JUNCTION FLATS
4433-4441 42ND AVENUE SW, SEATTLE, WA

DESIGN RECOMMENDATION MEETING
DPD #3013912

AUGUST 29, 2013

MASSING LEGEND

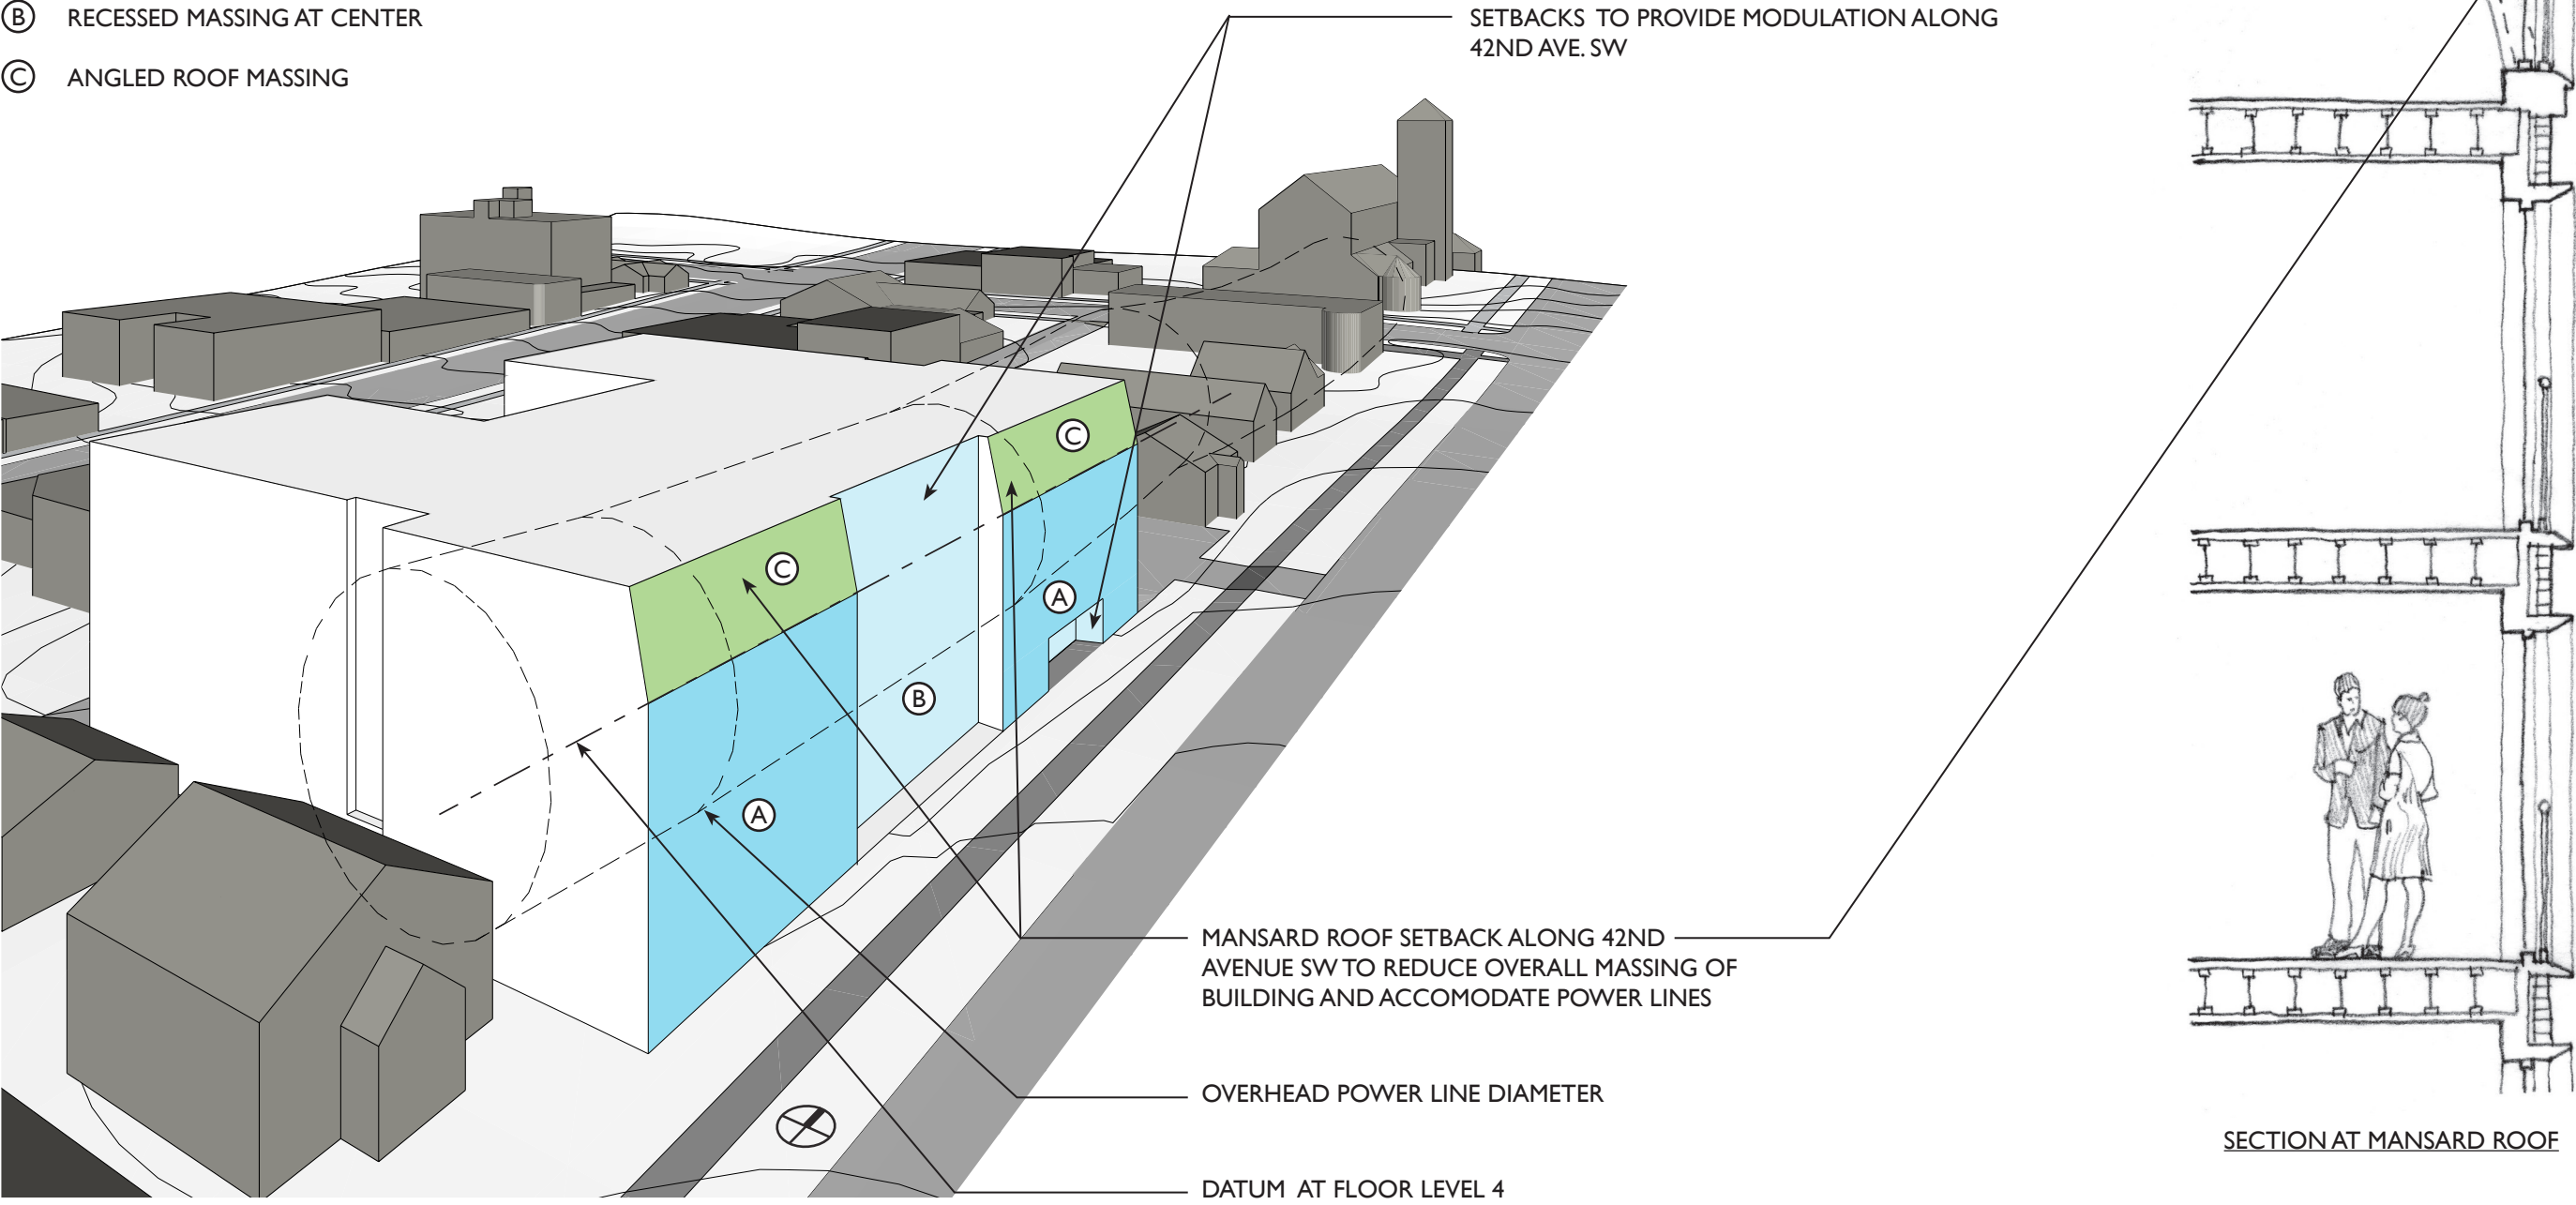
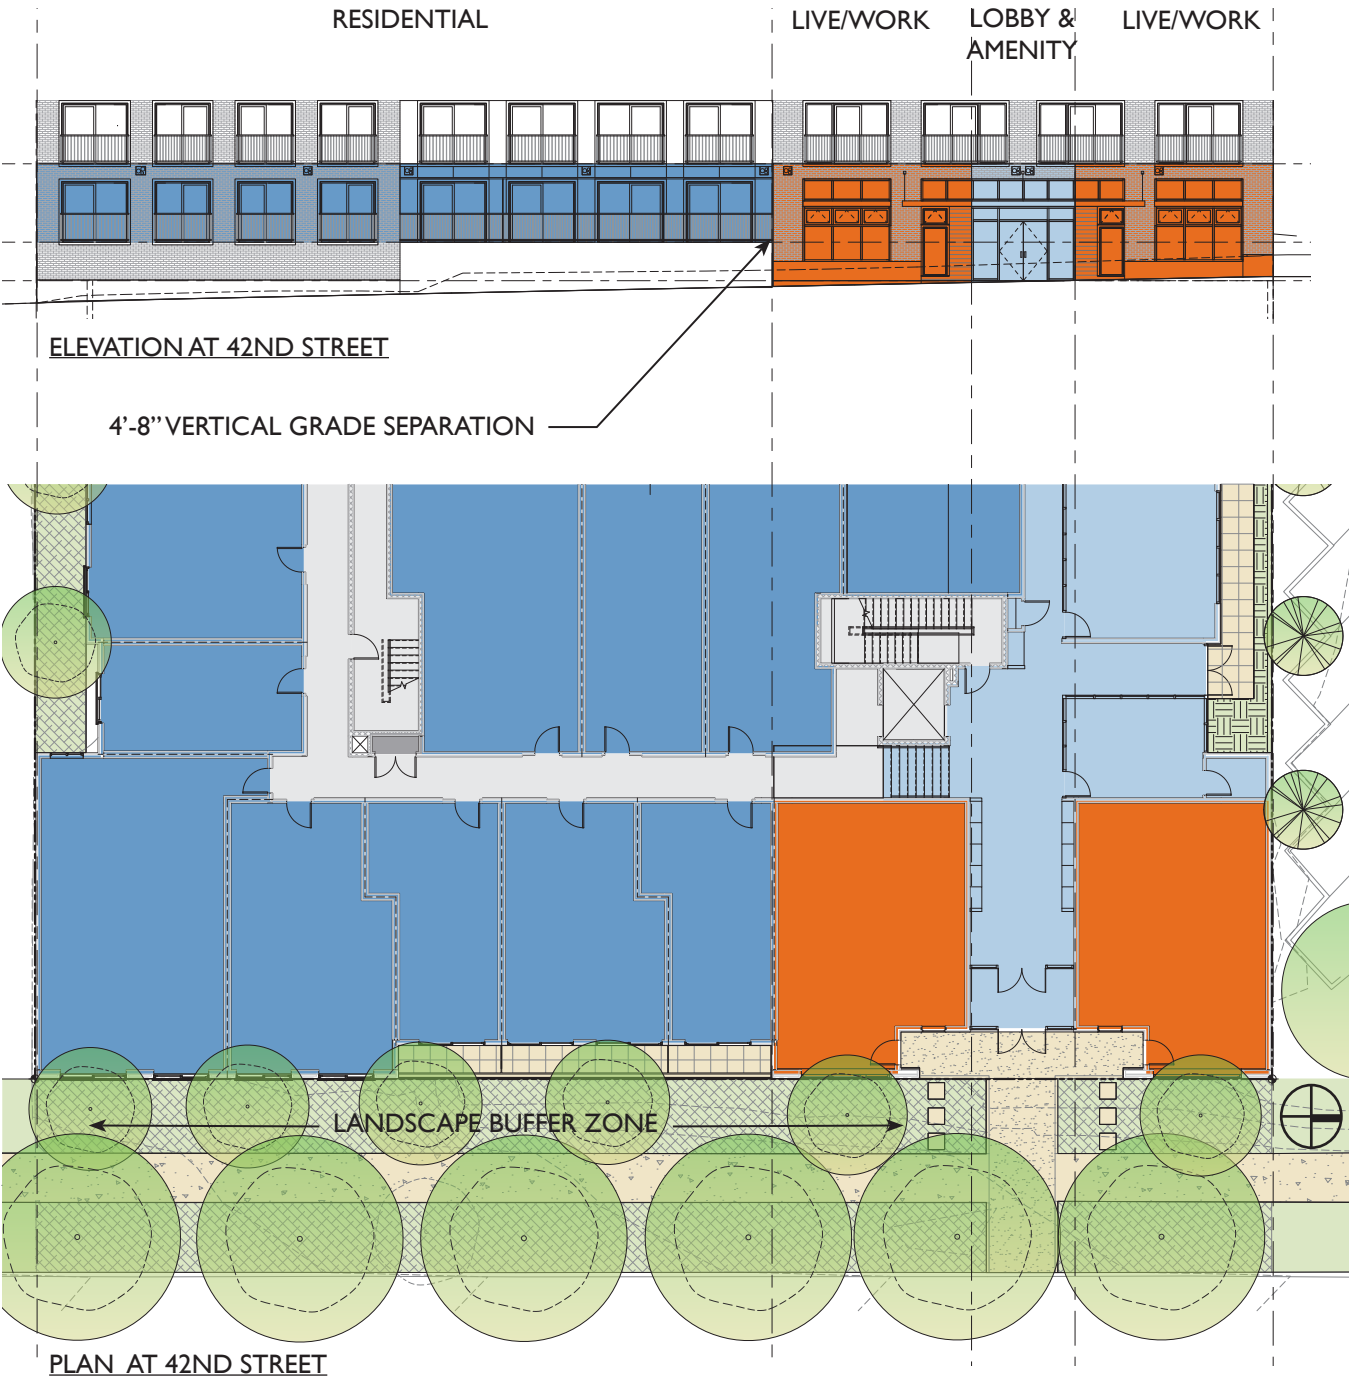
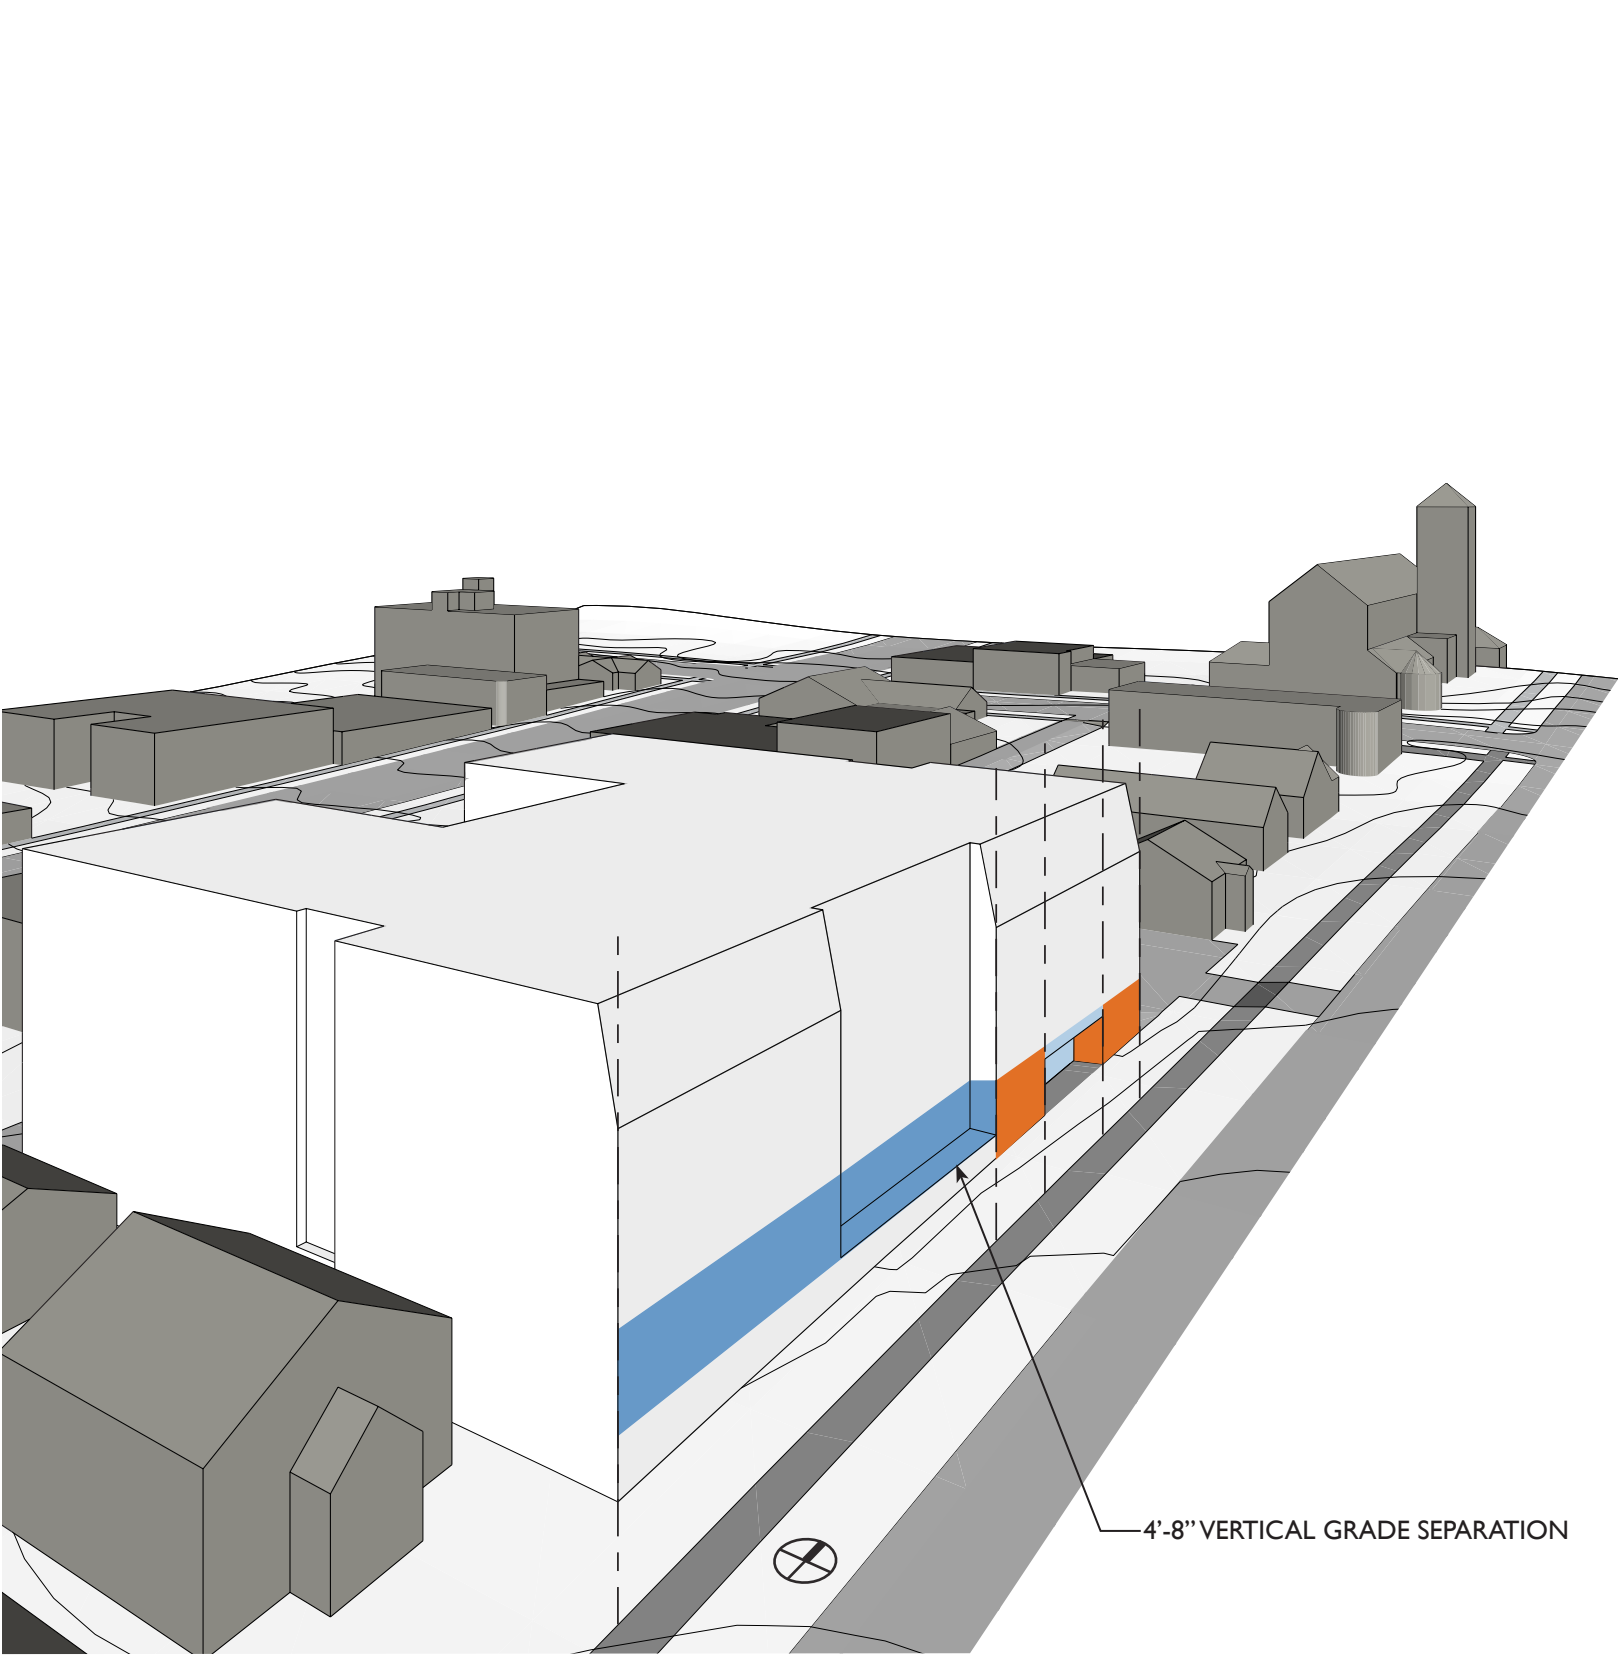
BOARD PRIORITY	RESPONSE
<i>(a.i) The Board felt the preferred design scheme Option 3 should move forward to Master Use Permit (MUP) submittal with the following guidance: More modulation applied to the 42nd Avenue Southwest façade is necessary to bring more interest to the building mass.</i>	Please see response to Item 2a.ii (below).
<i>(a.ii) The design should include elements from Option 1-including the distinct separation between the commercial (live-work units) and residential units at grade. Also the orientation of the residential lobby entrance situated towards the mid-portion of the structure at grade visually creates a good separation of uses. (B-1)</i>	<p>In the interest of simplicity and clarity, the design has evolved toward a stepped profile at grade, indicating the separation of uses:</p> <ol style="list-style-type: none">1. The residential building entry and live-work units are grouped to the north, filling out the footprint of the northern “bookend” at 42nd Ave SW. These public-oriented spaces are at sidewalk grade.2. Ground level residential units occupy the balance of the building footprint at 42nd Ave SW. These are raised a minimum of 4 feet above street level to mediate between private living spaces and the public street. <p>Please see analysis and illustrations pp.13-14</p>

The design of the new building should incorporate architectural features, elements and details to achieve a good human scale, encourage human activity, and reinforce the existing spatial characteristic of 42nd Avenue Southwest. (A-2,A-4, C-3)

BOARD PRIORITY	RESPONSE
<i>(a) The Board stated that a building with a strong street-facing urban edge and a softer urban edge to the west is appropriate. However, the Board expressed concern with the monolithic appearance of the building’s east-facing façades abutting 42nd Avenue Southwest. The Board expects to review a design at the Recommendation meeting that incorporates modulation with upper-level setbacks and recesses that breaks down the mass and adds interest and character. (B-1, C-3)</i>	<p>The proposed building concurs with the Board’s direction for a strong street face to the east and a softer edge at the west.</p> <p>The proposed massing is classically symmetrical with 2 brick-clad “bookends” framing a recessed bar deploying raised residential patios at grade against 42nd Ave SW and a landscaped courtyard at the alley. On the east façade, a mansard roof serves to reduce the apparent height of the structure, while indicating the building’s residential use. Large Juliet balconies are expressed as individual dormers against the inclined roof surface and this arrangement of openings continues rigorously through each floor below to create a strong, legible and symmetrical pattern at the facade. For emphasis, each opening at the roof and masonry faces is individually framed by an extruded metal frame in a contrasting color.</p> <p>The west façade is more conventional, with punched openings and accent panels expressed within a field. It is focused on a raised courtyard at the alley with heavy landscaping. Approximately half of the courtyard surface is devoted to planting beds. As the proposed storm water system includes a large bio-retention planter, unusually deep soil depths are available to accommodate larger trees. We anticipate the mature tree canopy will overhang the alley providing a buffer for west-facing residences and some relief from the utilitarian character of the alley.</p> <p>Please see analysis and illustrations pp.10-12 & p.17</p>
